## Town of Arlington, MA Redevelopment Board

## Agenda & Meeting Notice May 18, 2020

## Docket #2818, 880 Massachusetts Avenue \*Continued Public Hearing\*

Board will continue hearing for Special Permit Docket #3602 to review application by James F. Doherty for 1211 Mass Ave Realty Trust, at 1207-1211 Massachusetts Avenue, Arlington, MA, 02476, to construct a 50-room hotel and restaurant at 1207-1211 Massachusetts Avenue in the B2 Neighborhood Business District and B4 Vehicular Oriented Business District. The continuation of the hearing is to allow the Board to review and approve the application in accordance with the provisions of MGL Chapter 40A and the Town of Arlington Zoning Bylaw Section 3.4, Environmental Design Review.

Front Elevation (Massachusetts Avenue)

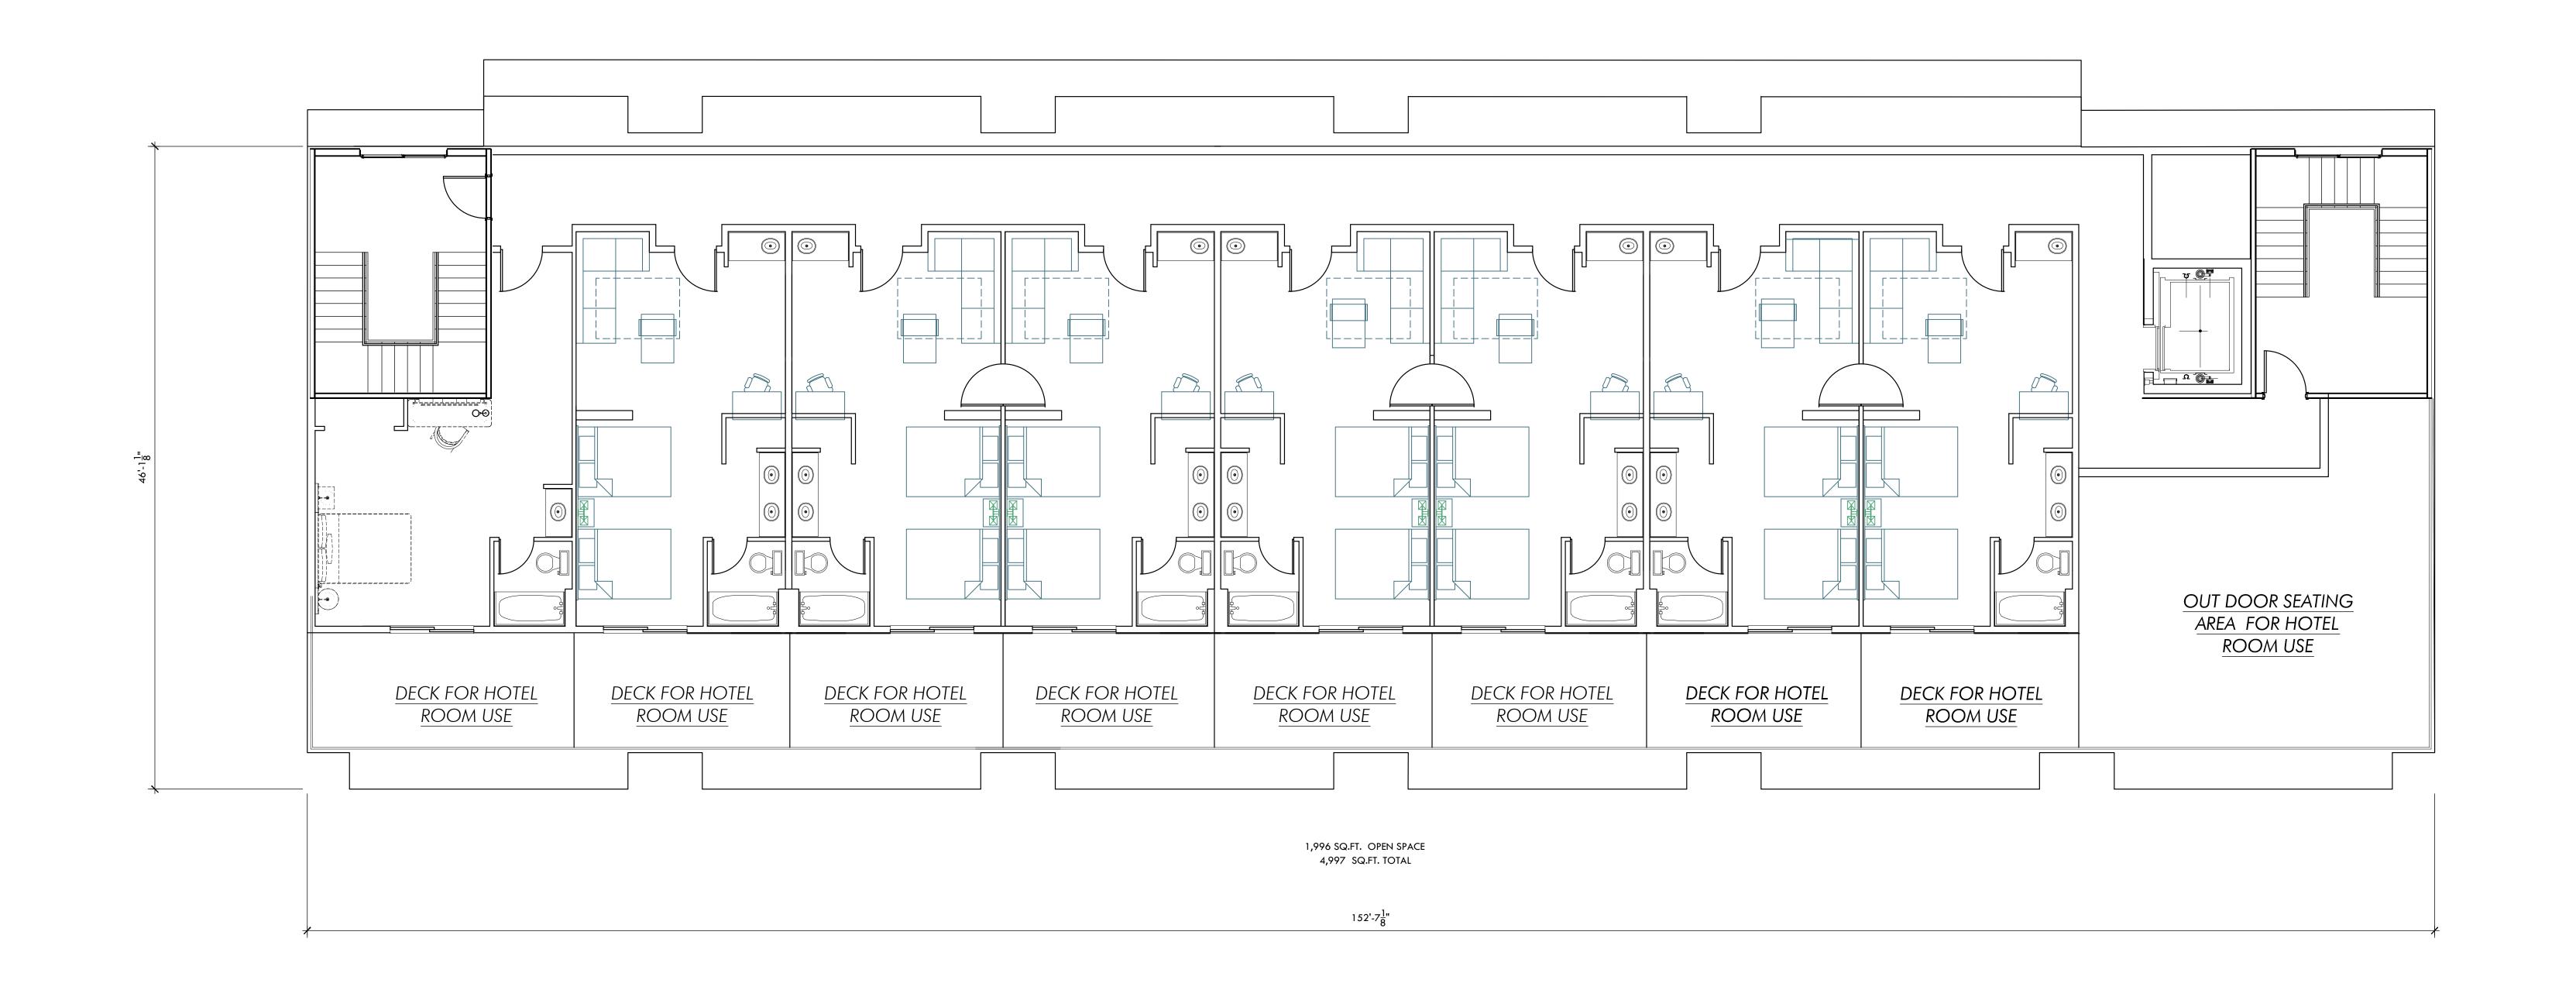
7. Re-evaluate the shadow study previously submitted to consider the existing shadows and provide a comparison and determine any impact to solar arrays in the neighborhood.

7. Take another look at your shadow study, consider the existing shadows and provide a comparison and determine any impact to solar arrays in the neighborhood;

The plan set includes an updated shadow study based on the new building. The plan set also includes a shadow study documenting the existing conditions of the building and shows trees at the rear of the site.

The plan set includes an updated shadow study based on the new building. The plan set also includes a shadow study documenting the existing conditions of the building and shows trees at the rear of the site. The updated materials do not identify if any of the adjacent buildings have solar arrays installed.

LAYOUT & MATERIALS PLAN | C-102

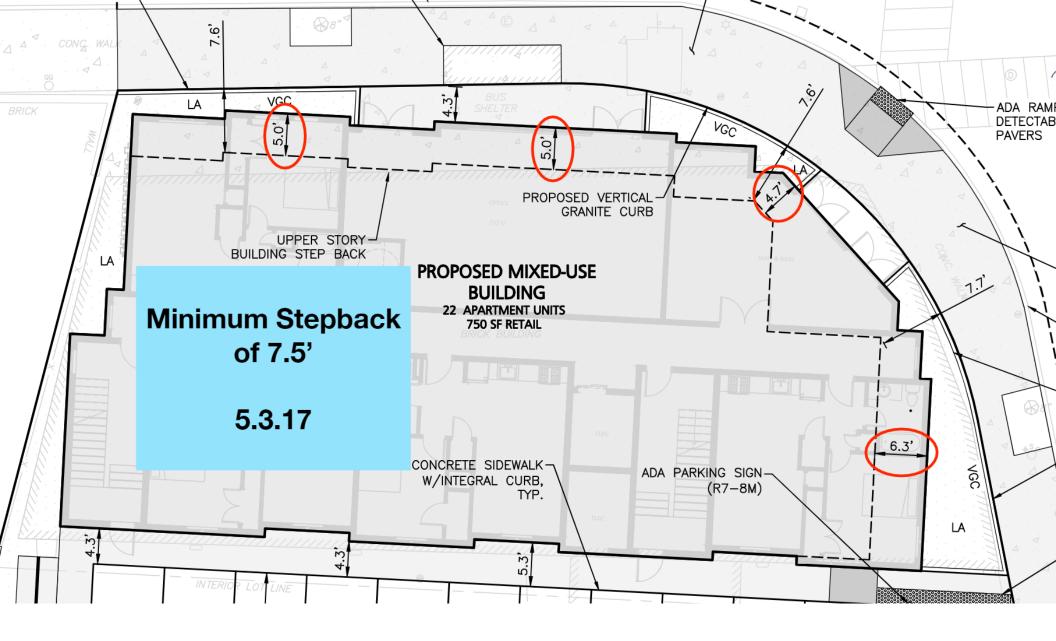
The property is a corner lot. 5.3.8 requires that on the Lockland St side the building setback be 20 feet.

The proposed apartment building requires significant Usable Open Space. There is no area on the lot that meets the definition of Usable Open Space.

- 5.3.17 requires an Upper Story Step-back beginning at the third floor, not the fourth as shown in the plans
- 5.3.17 also requires that this Step-back be a minimum of 7.5 feet. Only a very small portion of the proposed building meets

this requirement. It appears that the architect has misinterpreted the bylaw to mean a minimum distance from the front lot line rather the front of the building.
